Tri-Lakes Final Report Henny Property Project Whitley County, Indiana

November 2007

As you requested, we have reviewed the Tri-Lakes Design Report as prepared by JFNew, December 2005. Following are the comments and concerns we have generated. They are in no specific order, except that they generally follow the progression of the report.

RE: Tri Lakes POA- Thomas Henny Project Bid Addendum #1

Typical Check Dam Design

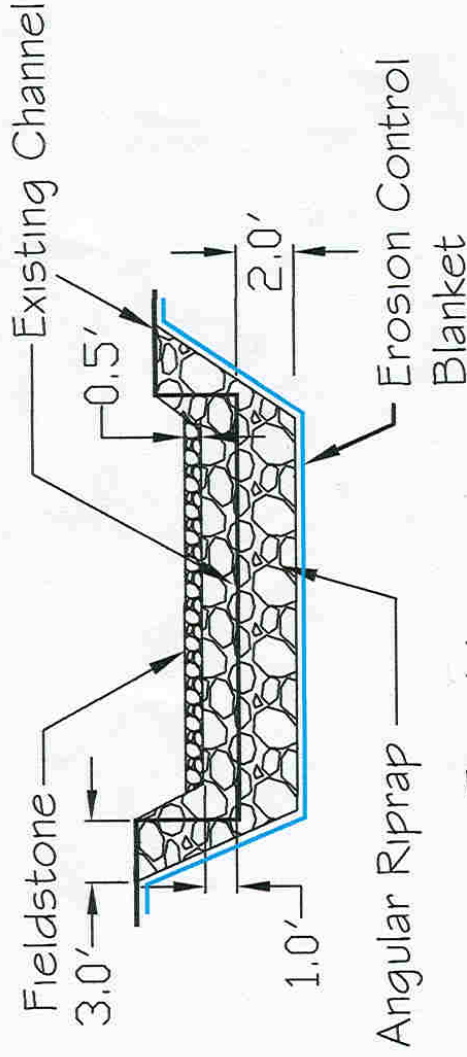
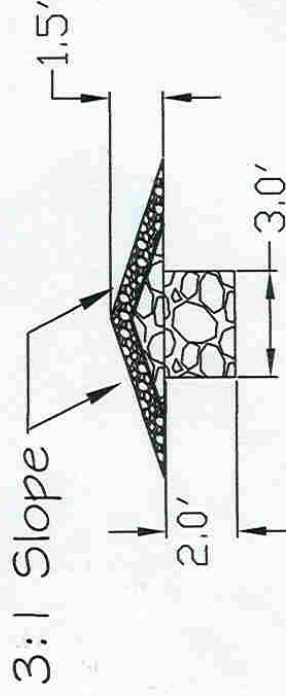
6. We are concerned about the effectiveness of the rock check dams as designed. Realize, we have not seen the site. According to the profile, there is considerable drop between the dams. Dam drops will cause velocity increases, which will increase velocities between the checks. Increased erosion will quickly fill the checks, canceling their detention ability. Perhaps consider adding plunge pools at the base of each check dam to dissipate energy there.

14. The check dams will be no longer than 25 feet in length and no taller than 1.5 feet above the existing stream grade. Keep in mind that the core trench on the check dams is three (3) feet thick and two (2) feet below grade.

15. All check dam location cross sections are not identical. They vary from 11 to 13 feet across and from 1.8 to 3.5 feet in depth. Add 8 feet to this width for calculations as the core trench must be keyed into each embankment by 4 feet.

3 RISER PIPE DETAIL
NOT TO SCALE

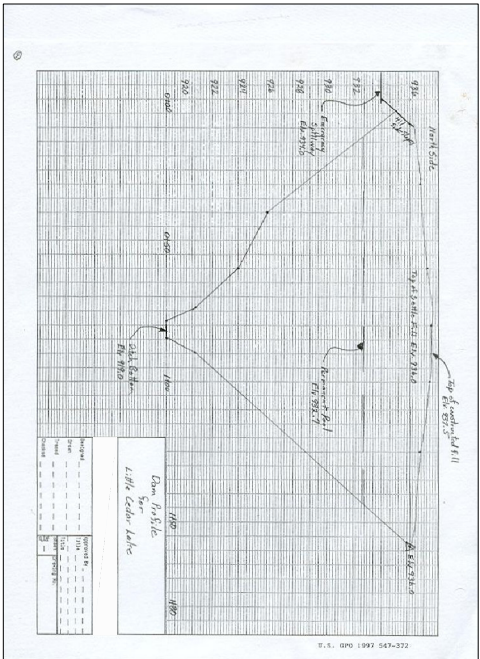
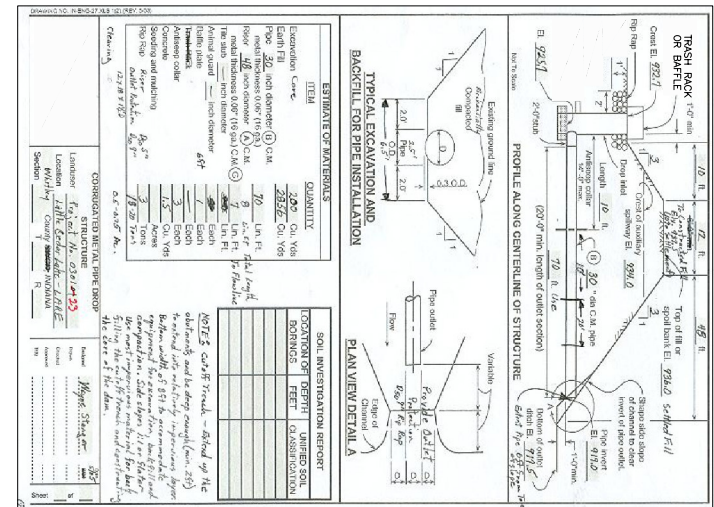
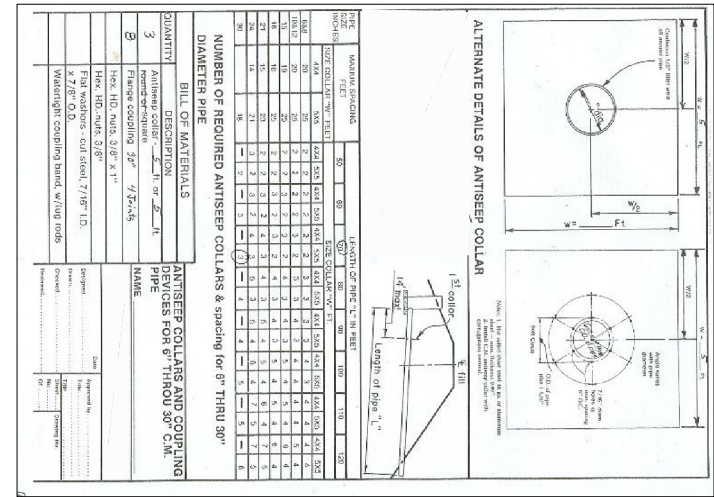
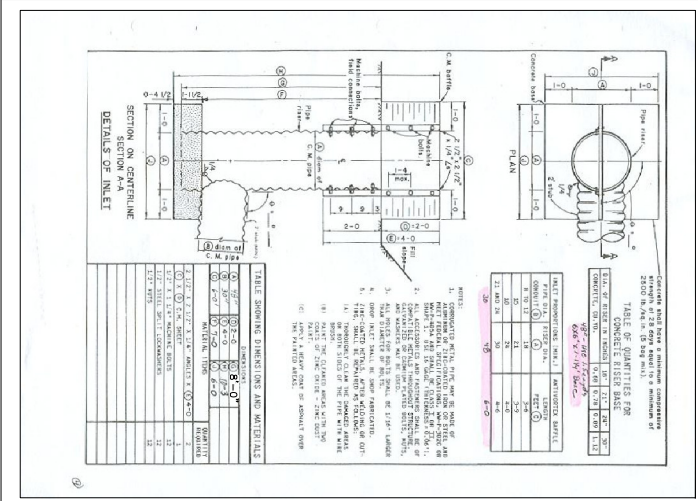
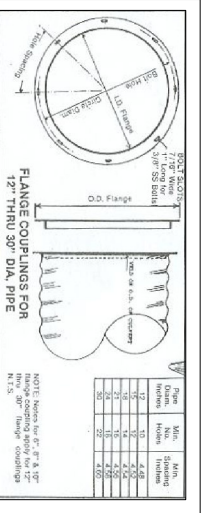
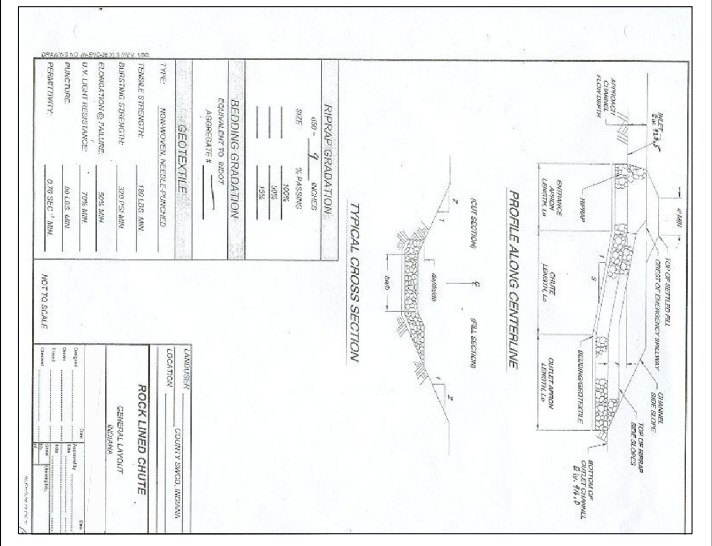
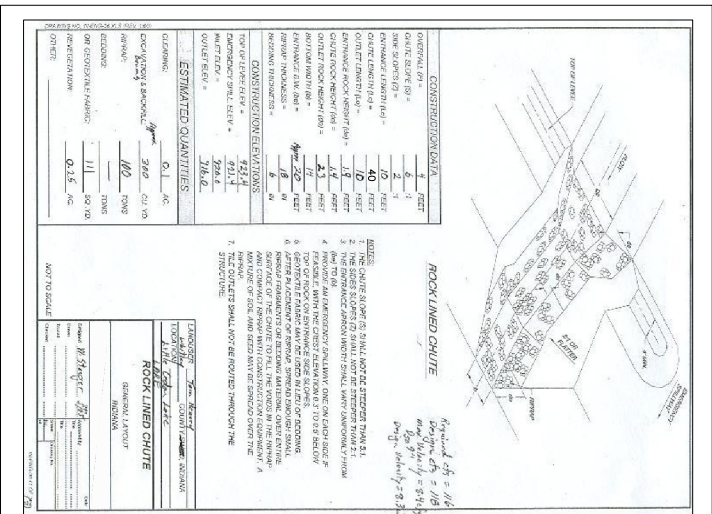
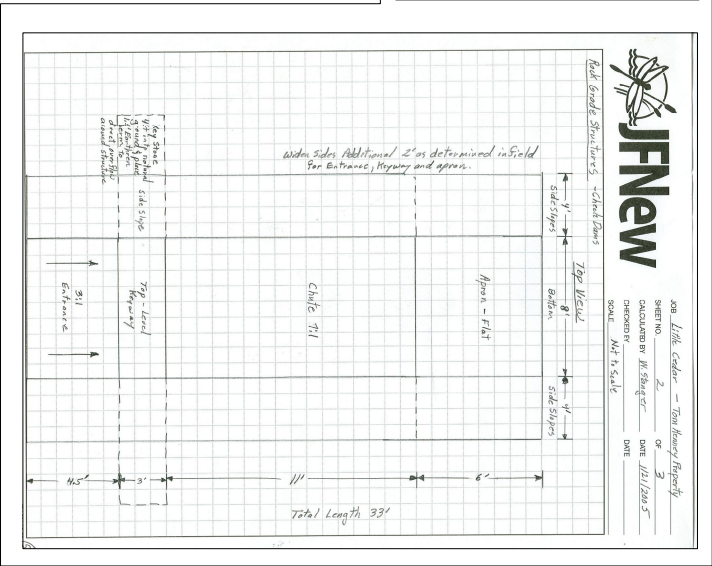
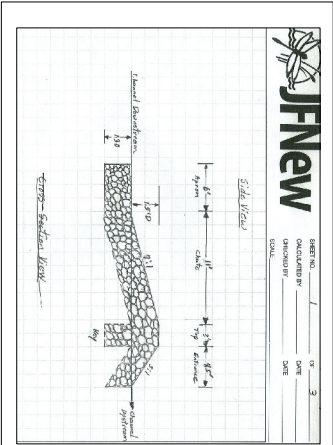
10. Page 2 of the outlet structure design shows the trash rack and baffle plate eliminated. Removing the baffle plate will allow a vortex, which will greatly reduce the capacity of the riser as it was calculated in the design notes.

Comments: The weir length controls the capacity of the structure. Full pipe flow will not be obtained. Consider raising the embankment to create additional head, or increasing the riser size to reach outlet conduit capacity.

- 1) The riser pipe shall be 48 inches in diameter and shall include a baffle plate and shown in the specifications.
- 2) All stone utilized in project shall have a D50 of nine (9) inches
- 3) During construction the dam will be tested with a penetrometer by a third party engineer for a minimum of every 1200 square feet of six-inch soil lift with no less than three tests per lift.
- 4) Anti-seep collars will not be used as per the current plans; however we will require the contractor to add a vertical filter layer and a toe-of-slope drain.
- 5) The owner will be responsible all annual maintenance of the dam, rock chute, and pond including silt removal should that become necessary.
- 6) The Tri Lakes POA will be responsible for necessary repairs to the structure and any government required inspections or studies.

- 1) The riser pipe shall be 48 inches in diameter and shall include a baffle plate and shown in the specifications.
- 2) All stone utilized in project shall have a D50 of nine (9) inches

9. The 48-inch riser pipe shall have a two (2') foot stub to connect the 30-inch horizontal pipe to, but shall not have a stub facing the pond.
10. The 30-inch pipe shall have welded flange couplings as shown in the details.
